Addendum No. 01 (One)

Date: 05/09/2025

Project: IN000A Site - Parking Lots 28 & 93 Repairs and Modifications

IU Project No: 20240389

C-001

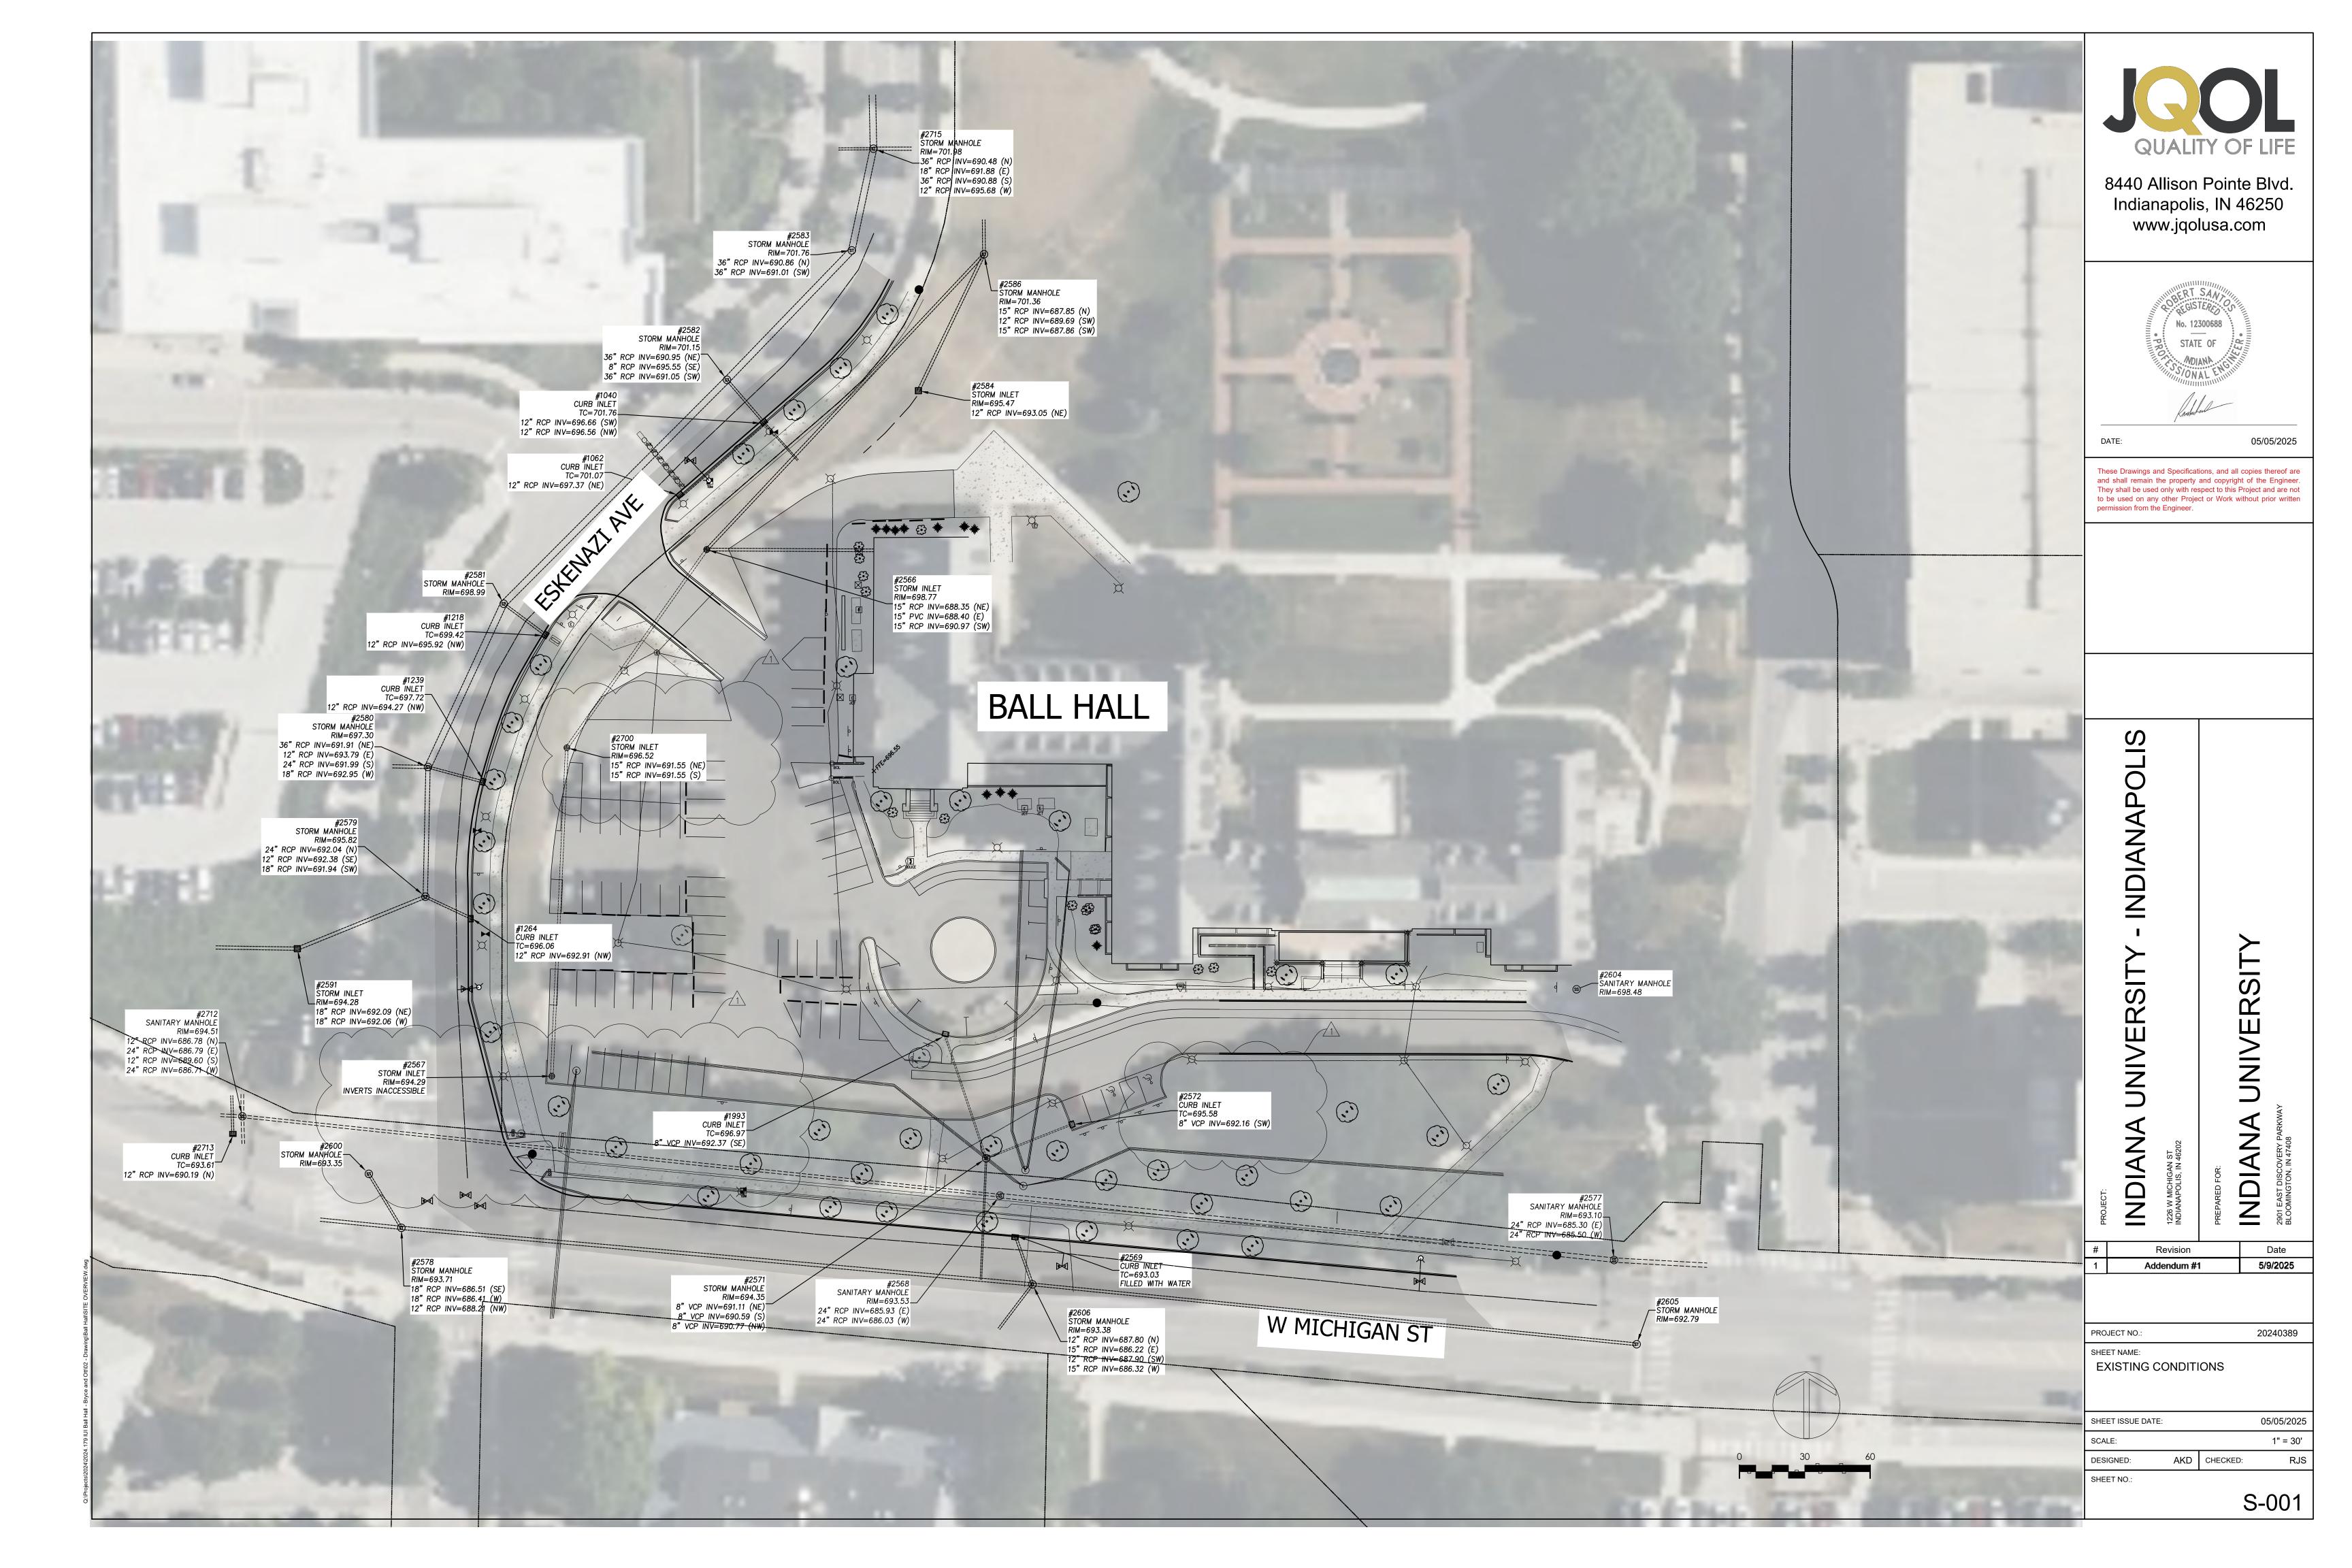
- Update to cover page index adding landscape plans
- Update to cover page index adding lighting plans
- Update to cover page changing owner to the trustees of Indiana University

20240389 SHEET NAME: D-101 DEMO PLAN

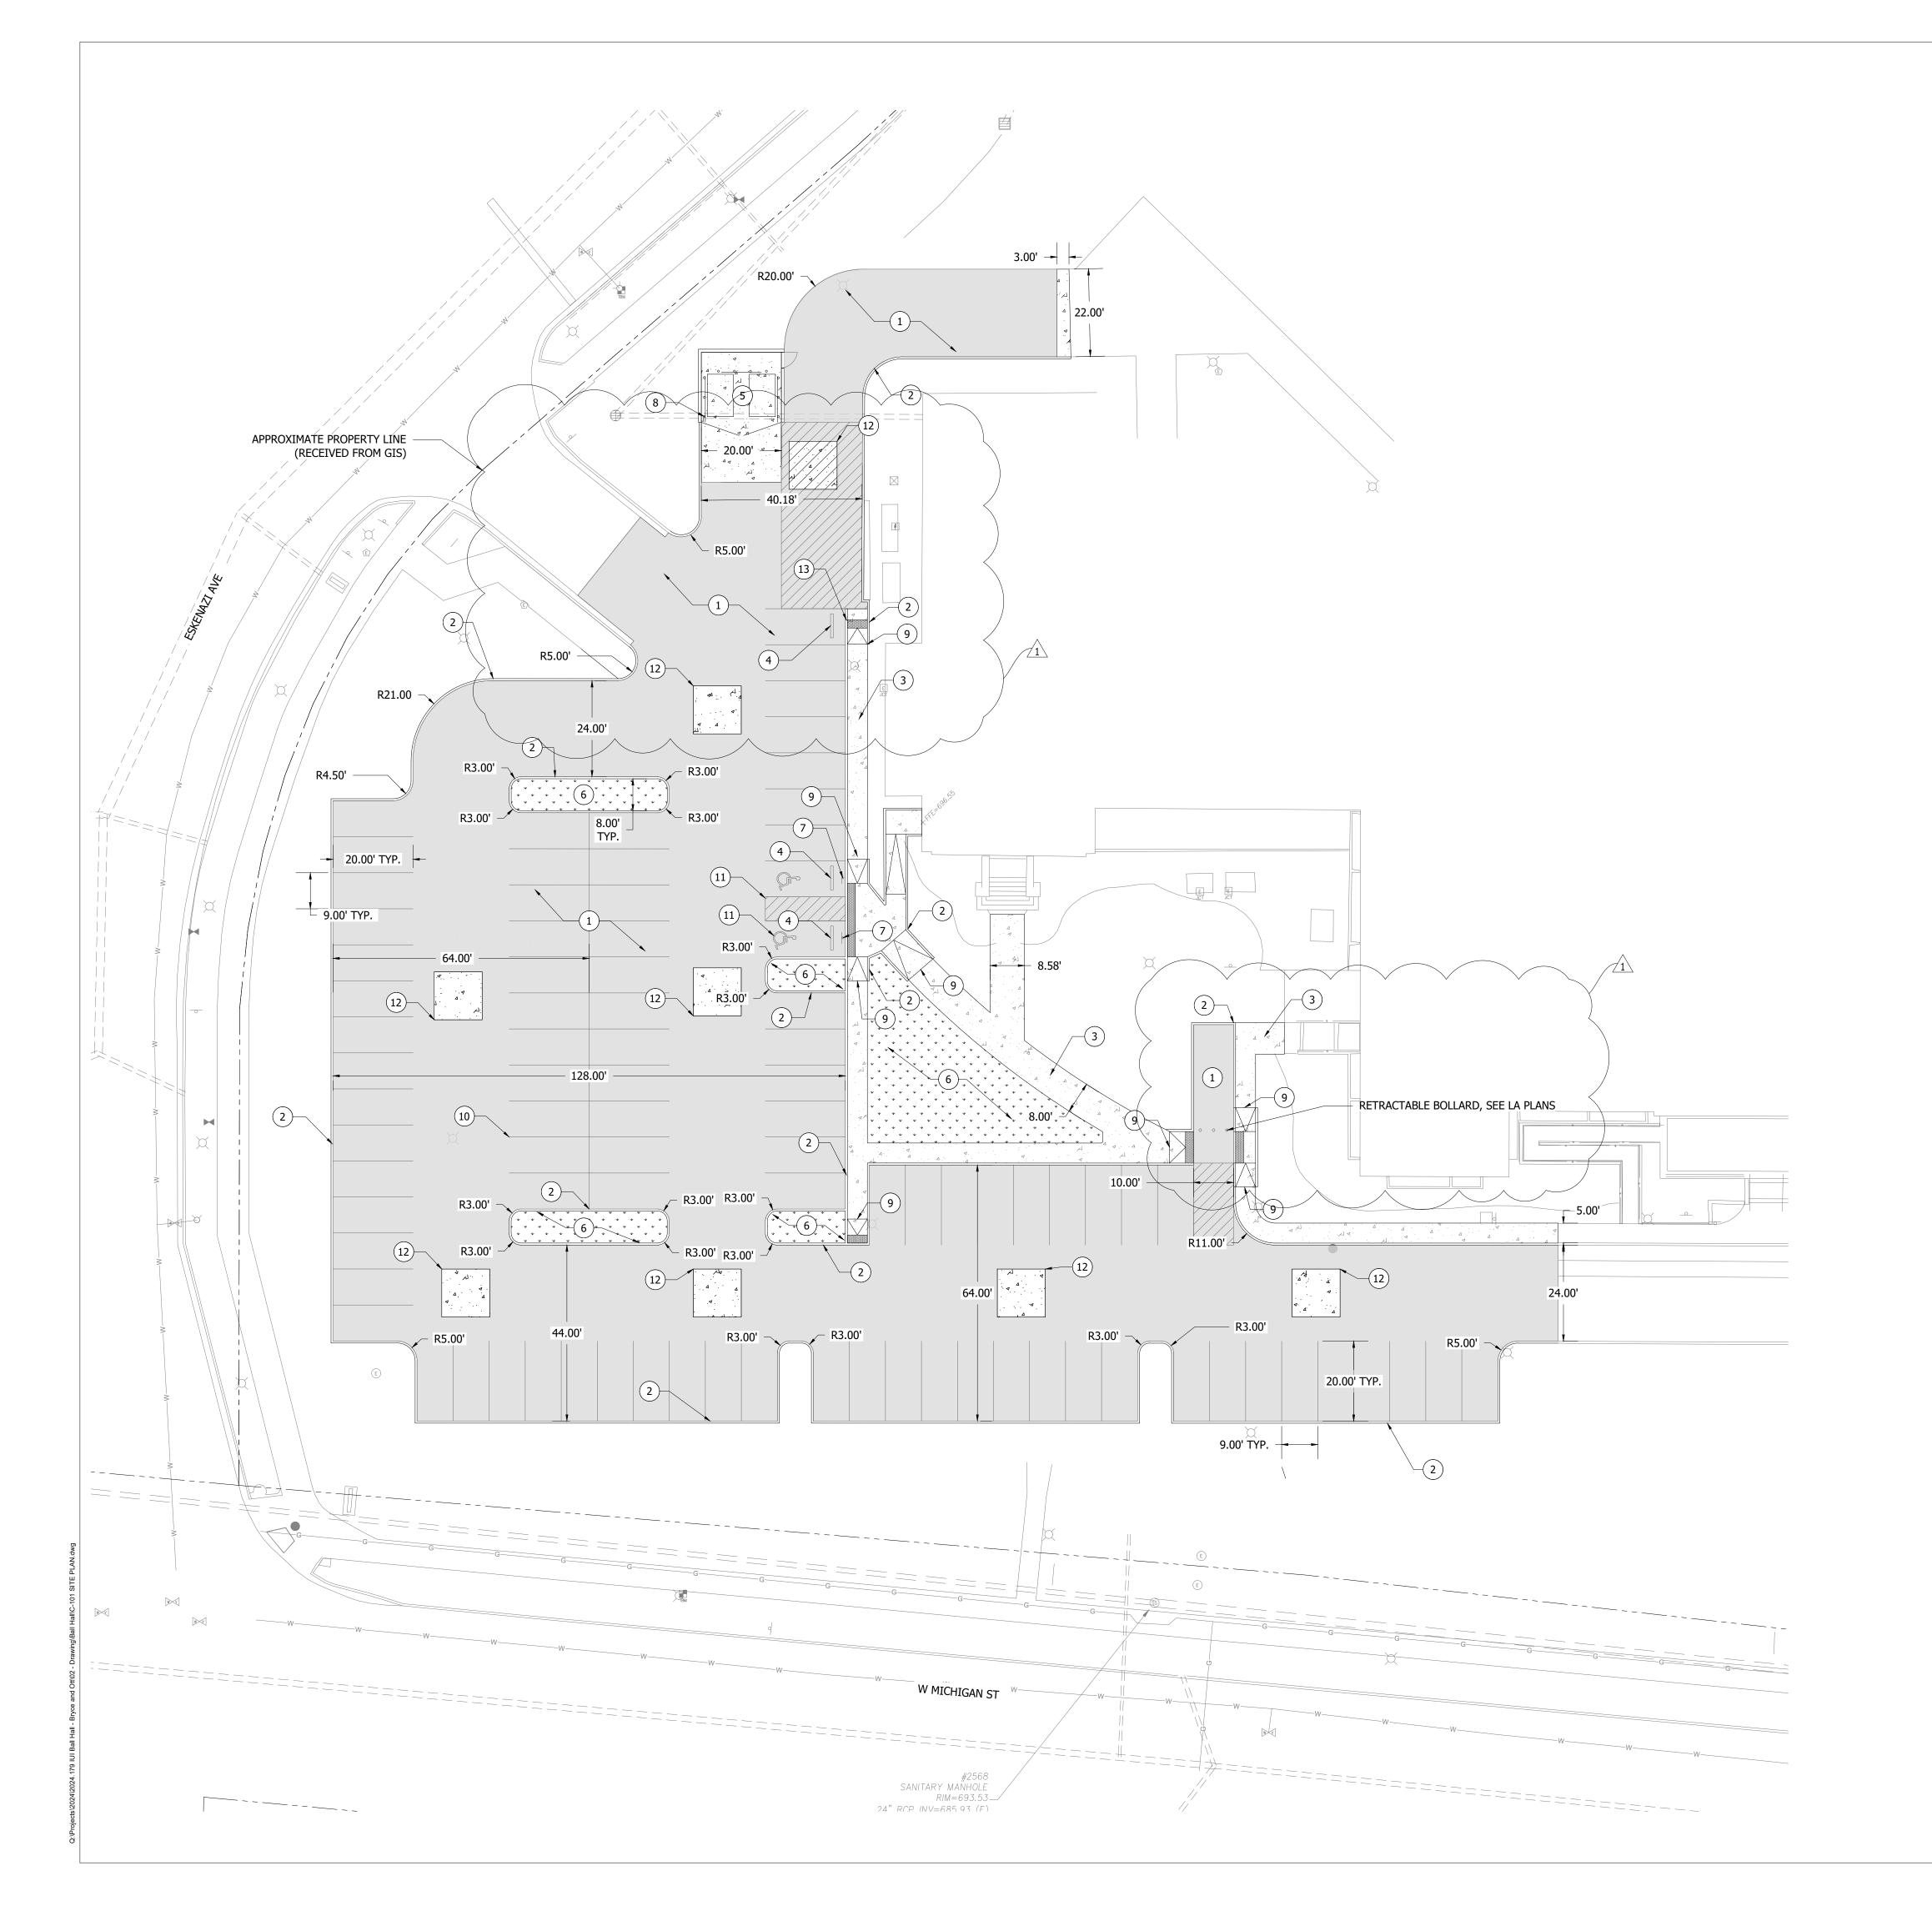
- Update to demo plan adding note for existing wall to be removed
- Update to demo plan adding note for existing wall to remain

SHEET NAME:
SITE PLAN

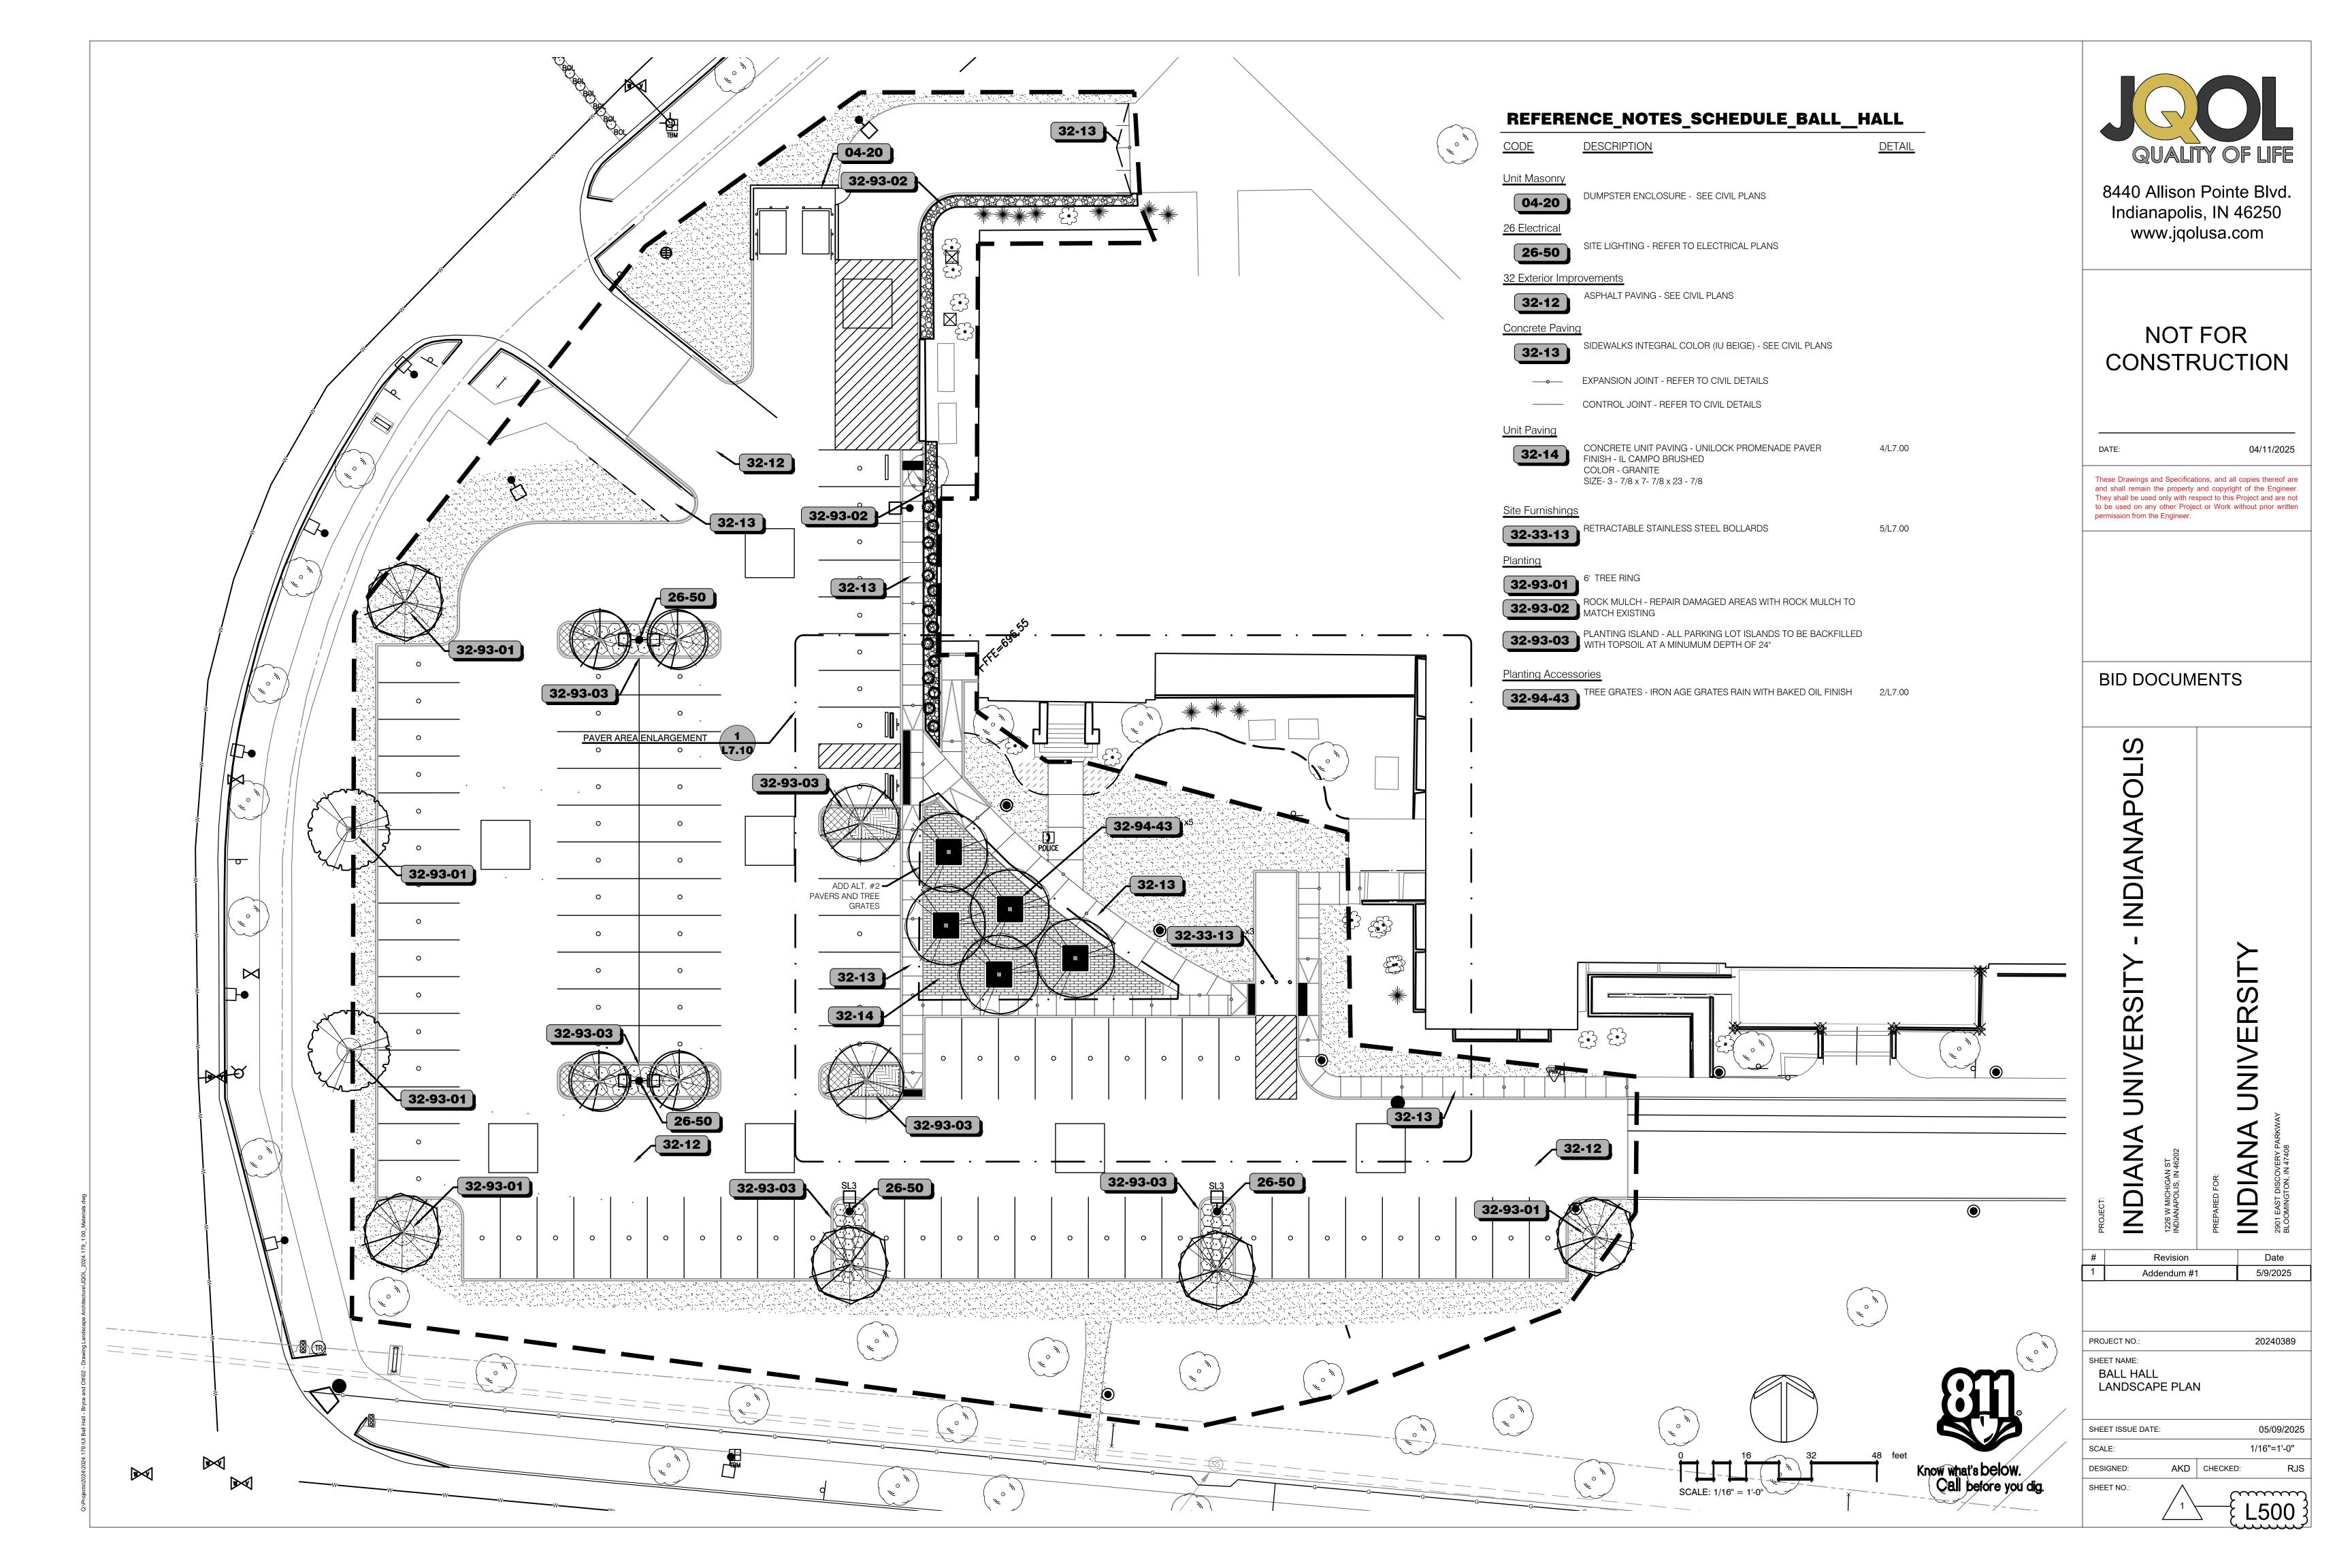
- Update to site plan changing the bollards to the north of the west curb ramp to be retractable
- Update to site plan changing curb to be flush with the walk
- Update to site plan extension of sidewalk next to the north entrance
- Update to site plan adjusted the curb line at the north entrance
- Update to site plan adjusted the north curb ramp around the existing wall to remain
- Update to site plan removed one parking spot at ramp
- Update to site plan adjusted striping
